**Assessment of Eight (8) Protected-Size Trees  
At and Adjacent to  
15602 Benedict Lane  
Los Gatos, California**

Prepared for:  
Ms. Jocelyn Shoopman, Associate Planner  
Town of Los Gatos Community Development Department  
110 E. Main Street  
Los Gatos, CA 95030

Report by CTA  
2/7/2022

## 12.0 Tree Location & Protection Fence Map Mark-up

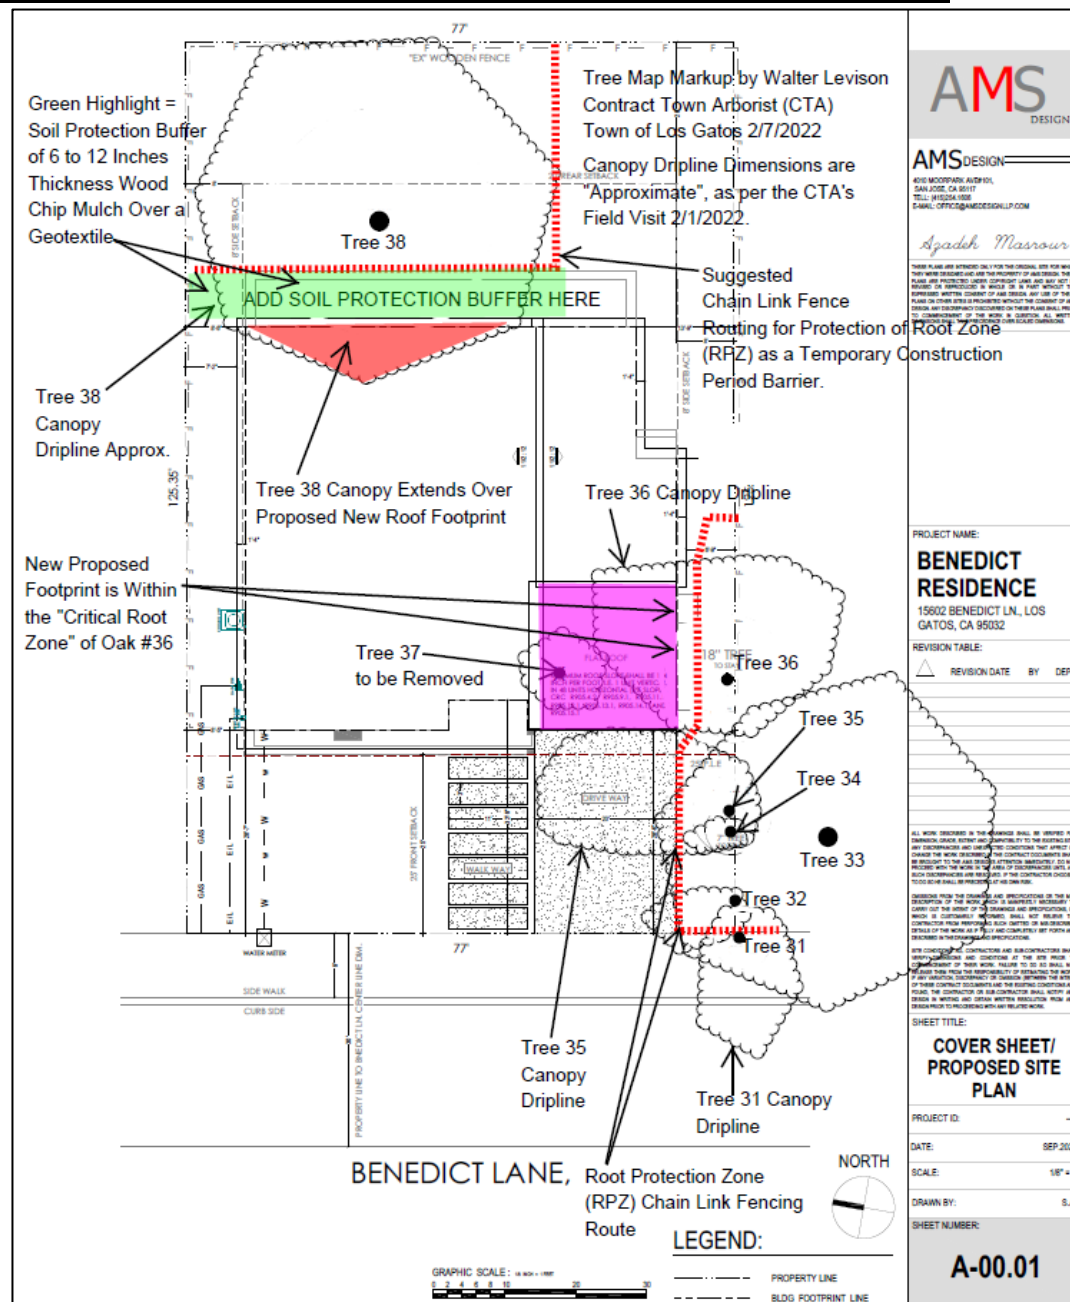
- Pushing the proposed new residence to 14 feet north of the trunk edge of tree #36, such that fencing can be erected at 9 feet north of trunk edge.
- Installing a soil protection buffer between the tree #38 protection fence and the proposed new residence foundation edge, per the **green** highlighted strip shown on the CTA's tree map markup below at the end of this report.

**Trees #31, 32, 33, 34, and #38** are expected to remain with little or no negative impact from proposed new site plan construction work, if fencing is erected along the south edge of the proposed driveway footprint as indicated on the CTA's tree map markup as a heavy red dashed line.

The current proposed applicant plan shows the new residence foundation at 6 feet north of trunk edge of tree #36: a distance that is inside the critical root zone (CRZ) of the tree, calculated at 8.5 feet radius offset.

The CTA suggests that Staff consider requiring the applicant to push the new residence foundation to 14 feet north of trunk edge of oak #36, (if this tree is to be retained), in order that TPZ chain link fencing can be erected at 9 feet north of trunk edge, thereby bringing the fenced off root zone area to just north of the calculated critical root zone offset distance from trunk edge. This will also allow for creation of a 5-foot wide construction corridor between the TPZ fence and the new foundation where construction personnel can walk and perform work without being blocked or hindered by the fencing.

**Pre-construction fence: Per the red dashed lines on the tree map mark-up in the CTA's arborist report (routes may be subject to change, depending on the finalized alignments of work items).**

The CTA marked up the applicant's sheet A-00.01 "Proposed Site Plan" by AMS Design, dated September, 2021.
